From: Phil Carlson, Stantec

Date: May 25, 2020

**Re: Suite Living of Spring Lake Park  
Planned Unit Development & Site Plan Review, 525 Osborne Road NE**

**Setbacks**

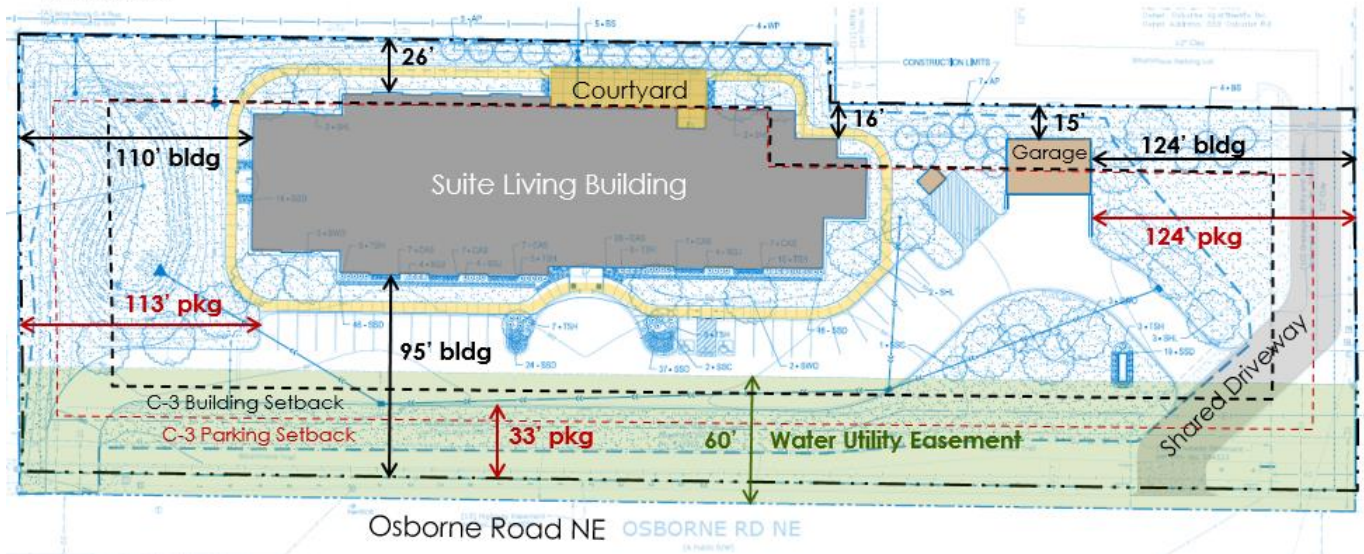
- *Front setback/building.* The required front setback (Osborne Road) for a building is 40 ft. Because of the large water utility easement and the row of parking in front of the building, the front setback is easily met with a 95 ft setback.
- *Front setback/parking.* The required front setback (Osborne Road) for parking is 25 ft. Because of the large water utility easement in front of the building, the front parking setback is easily met with a 33 ft setback.

- *East side setback/building.* The required side setback to the east (church, R-1 district) is 40 ft, which is easily met with a 232 ft setback to the building and a 124 ft setback to the garage. Accessory buildings must adhere to the front and side setbacks.

- *East side setback/parking.* The required side setback to parking (church, R-1 district) is 20 ft, which is easily met with a 124 ft setback to the new loading area in front of the garage. The project will use the existing access driveway off Osborne Road to the Osborne Apartments. The driveway is setback 7 feet from the east lot line.

- *West side setback/building.* The required side setback to the west (C-3 district) is 15 ft, which is easily met with a 110 ft setback. Even though the use of the property immediately to the west is residential, it is zoned commercial and the greater setback requirements are to zoning districts, not uses.

- *West side setback/parking.* The required side setback to the west (C-3 district) is 15 ft, which is easily met with a 113 ft setback. Even though the use of the property immediately to the west is residential, it is zoned commercial.

- *Rear (north) setback/building and parking.* The required rear setback to the north (R-3 district) is 30 ft for both buildings and parking. Most of the building façade has a 26 ft setback to the north lot line abutting the Spring Crest townhomes, which is 4 ft less than the required 30 ft. In the middle of the site near the NE corner of the proposed building there is a jog in the lot line where it abuts the Osborne Apartments parking lot. There, the setback to the building is 16 ft, 14 ft less than the 30 ft requirement. The proposed garage has a 15 ft setback to the north/rear lot line, also less than the 30 ft requirement. There is a proposed fenced courtyard on the north side of the Suite Living building, but fences are allowed within the rear yard setback.

**Vicinity with Site Plan Superimposed**

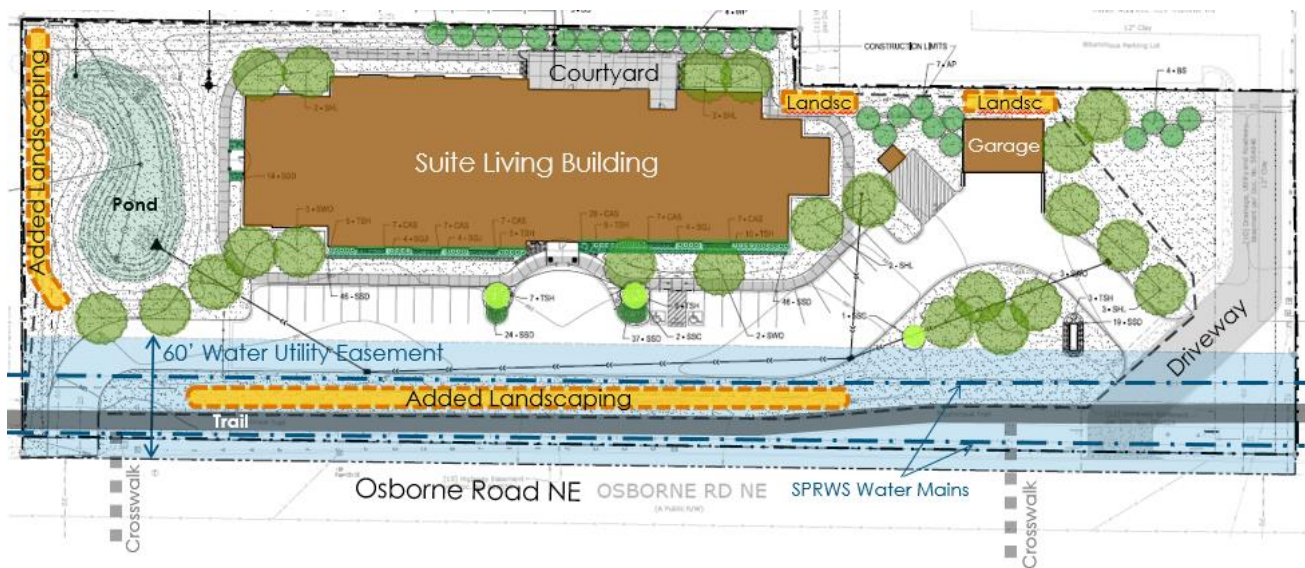
The proposed Suite Living site plan in relation to the surrounding uses is illustrated below. On the north side of the proposed building the setbacks are only 4 ft less than required by Code – 26 ft vs. 30 ft. This area is landscaped abutting Spring Crest Estates and also on the Suite Living site in the proposed landscape plan. Where the Suite Living site abuts the Osborne Apartments parking lot the setbacks are 15 ft and 16 ft, compared to 30 ft required. This area has proposed landscaping along most but not all of this edge. Just north of the apartment parking lot is an outdoor open space area used by residents. Providing landscaping along the entire north edge of the Suite Living site here would be desirable. Additional landscaping would also be desirable on the west edge of the site to screen and separate the adjacent residential neighbor from the storm pond. Screening of parking areas is also required by the Zoning Code and additional landscaping could be added south of the parking lot in the water utility easement, if approved by SPRWS.
